UNITED STATES PATENT AND TRADEMARK OFFICE

APPLICATION NO.	FILING DATE	FIRST NAMED INVENTOR	ATTORNEY DOCKET NO.	CONFIRMATION NO.
09/891,589	06/27/2001	Kiichiro Takahashi	684.3203	2104

Office Action Summary

DETAILED ACTION

FIG. 2

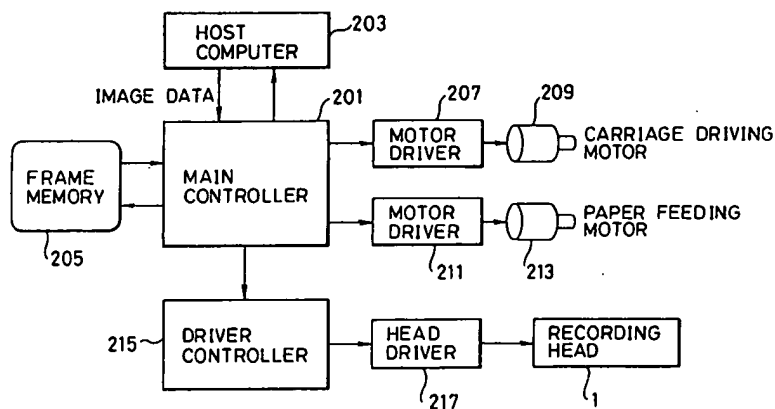
14. Claims 1-3 are rejected under 35 U.S.C. 102(b) as being anticipated by Takagi (US Pat 5384587). Referring to claims 1-3, Takagi discloses an ink jet recording apparatus/method for effecting recording on a recording material by ejecting ink (See figure 1; column 1, lines 8-11), as well as a data processing method of processing data to be supplied to an ink jet recording apparatus for effecting recording on a recording material (See column 1, line 9; The disclosed generation of clear images represents a type of data processing method), both with relative scanning movement by ejecting ink with relative scanning movement between a recording head and the recording material (See figures 1-18; column 1, lines 29-34); an obtaining means/step for obtaining information indicative of an amount of ink to be ejected to each of unit areas provided by dividing an area in the neighborhood of a boundary between adjacent bands of scanning recording material (See figure 2, references 201 and 203; column 4, lines 63-64; column 5, lines 14-17; and column 7, lines 18-25); and a control means/step for controlling an amount of being to be ejected to the unit area on the basis of the output of the obtaining means (See figure 2, reference 201; column 4, lines 63-64; and column 7, lines 9-33),

FIG. 4

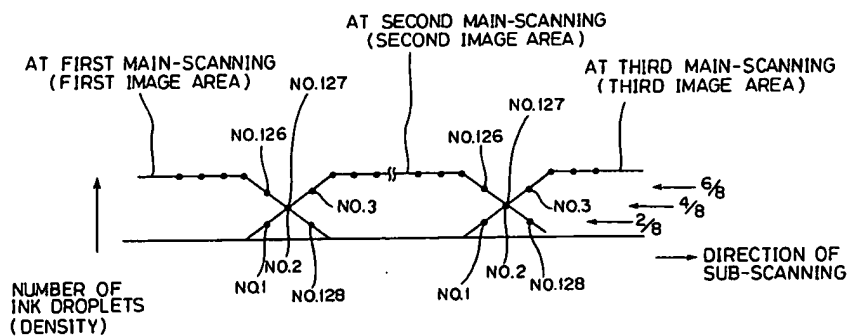
wherein the unit areas astride the boundary between adjacent one of the bands (See figure 4; column 11, 47-53).

FIG. 3

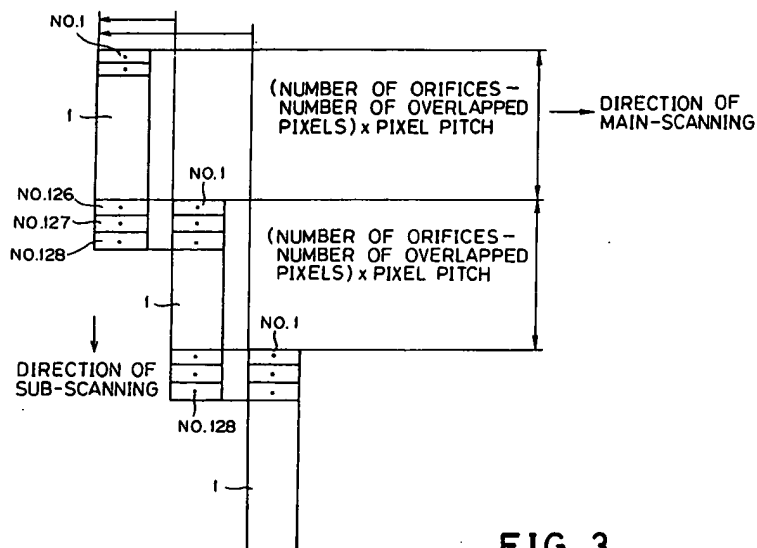
However, Takagi does teach, with respect to claims 4-6, 11, and 13 that "The number of ink droplets that may be landed on one pixel may be controlled based on the density data." (See column 4, lines 63-64). Furthermore, in regards to Figure 3, Takagi teaches "the number of ink droplets forming each pixel according to image data differs from each other." From the descriptions of figures 3 and 4, it is clear that each of the unit areas are divided in the

neighborhood of a boundary between adjacent bands of scanning recording of the recording head on the recording material.

Therefore, in order to properly enable the production of the different number of ink droplets that may be landed on one pixel, there must be an implicit means for counting the ink ejection data number. Thus, it will be assumed that Takagi implicitly implies a dot count means for counting the ink ejection data number for each of the unit areas provided by dividing an area in the neighborhood of a boundary between adjacent bands of scanning recording of the recording head on the recording material, though it does not explicitly state so. Furthermore, Takagi teaches, with respect to claim 5, "When recording is performed on the recording sheet at the first main-scanning time, the orifices Nos. 1, 2, ..., and 128 are used. At this time, as shown in FIG. 4, the numbers of ink droplets discharged from the orifices Nos. 126, 127 and 128 are determined as $N \times 6/8$, $N \times 4/8$ and $N \times 2/8$ respectively for forming the first image area." (See figures 3 and 4; column 7, lines 53-59) Here, the factors $6/8$, $4/8$, and $2/8$ represent different weights that are applied to the ink ejection bands. Next, Takagi teaches, with respect to claim 6, "a recording sheet is moved or sub-scanned upward by 125 pixels so that the orifices Nos. 1, 2, and 3 overlap part of the first image area formed by the orifices Nos. 126, 127 and 128 respectively..." (See

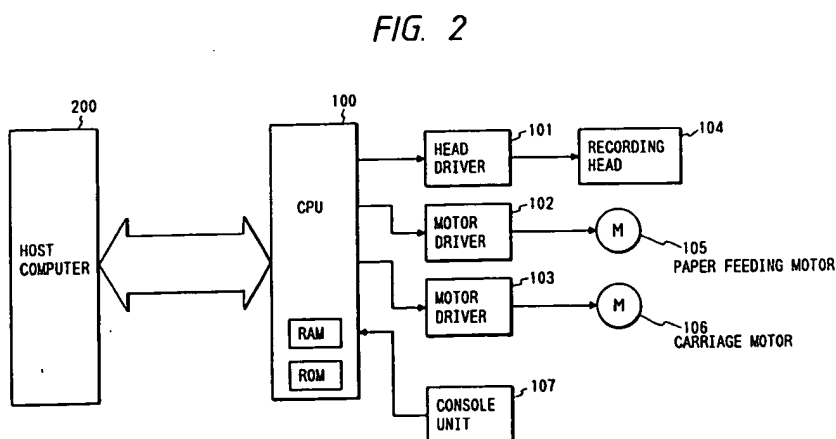
figure 3; column 7, lines 60-64) Thus Takagi discloses that the dot count means not only counts the ink ejection data number with weighting for each of the bands, but it also counts the ink ejection data number with weighting which is different in the sub-scan direction.

Nagoshi teaches, with respect to claims 4,11, and 13. "The CPU 100 controls the driving operation of the carriage motor 106 so that the single- and multi-pass print modes have different scan speeds. When the CPU 100 receives data from the host computer 200, it drives the carriage motor 106 to cause the carriage unit 2 to travel, thereby starting the main scan operation" (See figure 2, references 100, 106, and 200; column 4, lines 32-39). Thus, Nagoshi discloses a CPU 100, which not only receives data (i.e. dot count data [of which data about distance from boundary is inherent]) from the host computer, but also from that data, controls scanning speed, which directly relates to thinning rate in this invention. Thus Nagoshi discloses a determining means for determining a thinning rate for each of the unit areas on the basis of an output of said dot count means and a distance from the boundary.
